Form C-103
Revised August 1, 2011

Bill's Hopper No. 2
Edison North Field
Lea County, NM

API: 30-025-36081

P&A Wellbore

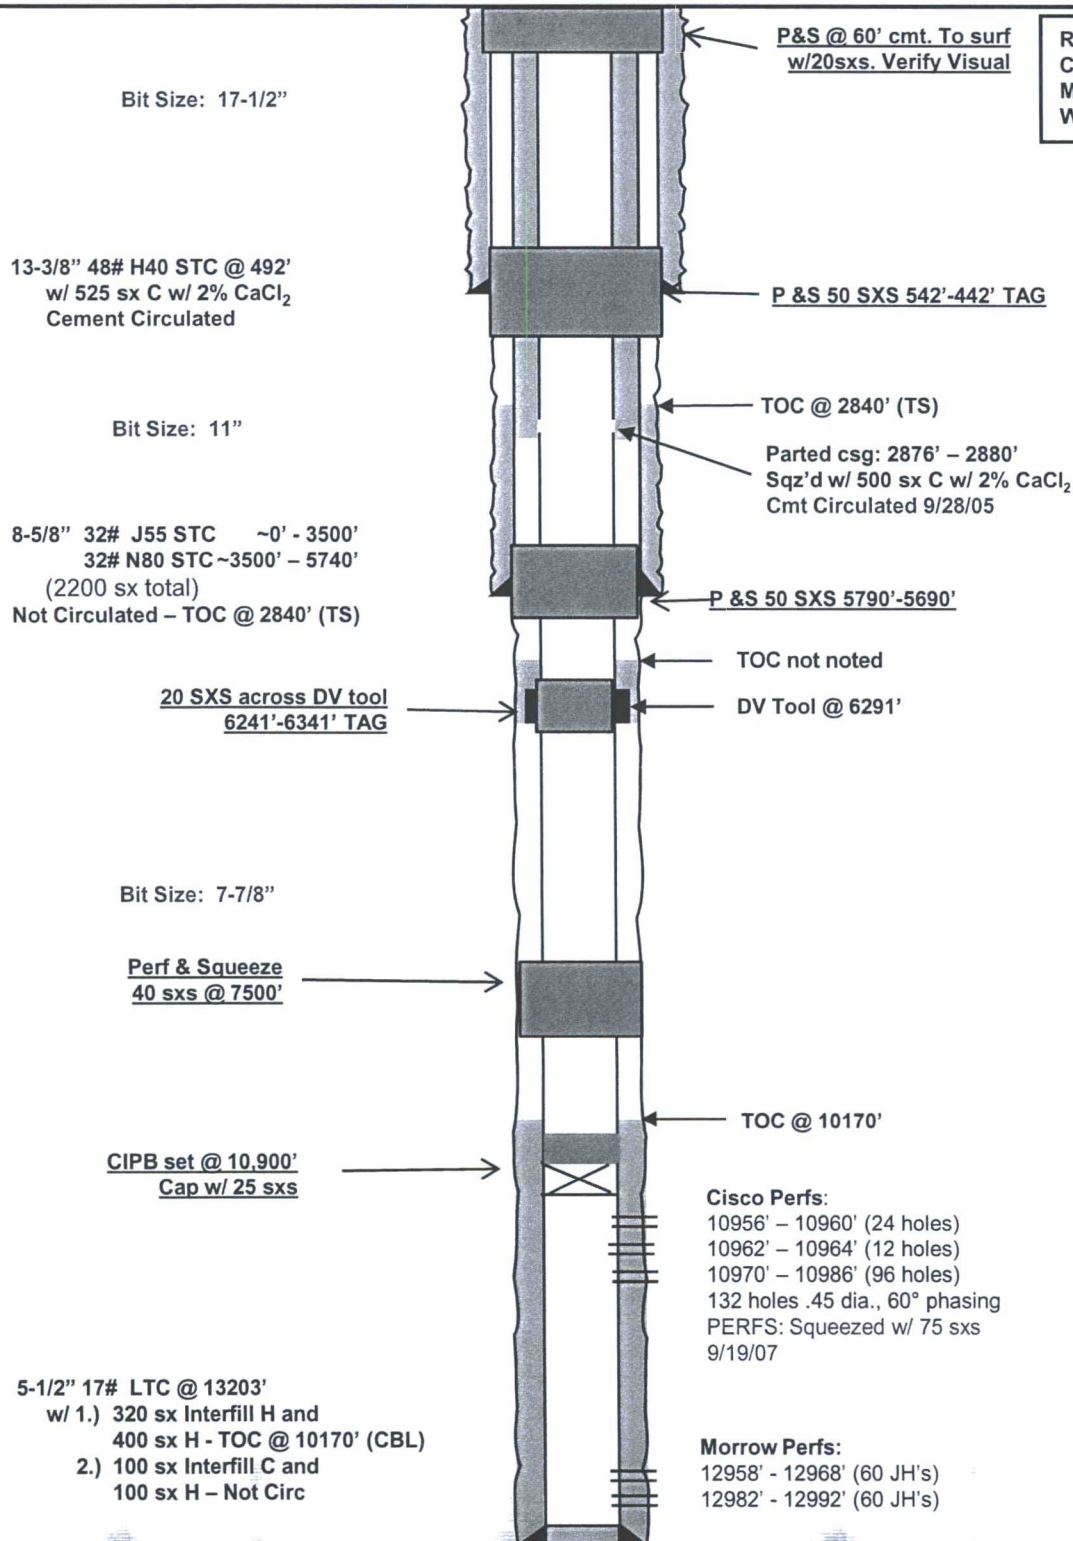
SET CIBP @ 12,900'. DUMP BAIL 35' OR CAP w/ 25 SX CLASS 'H'

CIRCULATE MUD LADEN FLUID
BETWEEN PLUGS

SPOT 25 SX cmt at 2930'
(Casing part & B. SALT)
PERF at 1900' ATTEMPT TO SQZ
WITH 50 SX. WOL. Tag at 1800' OR BETTER
(T. SALT)

NOTIFY OCD 24 HOURS PRIOR TO
BEGINNING PLUGGING OPERATIONS
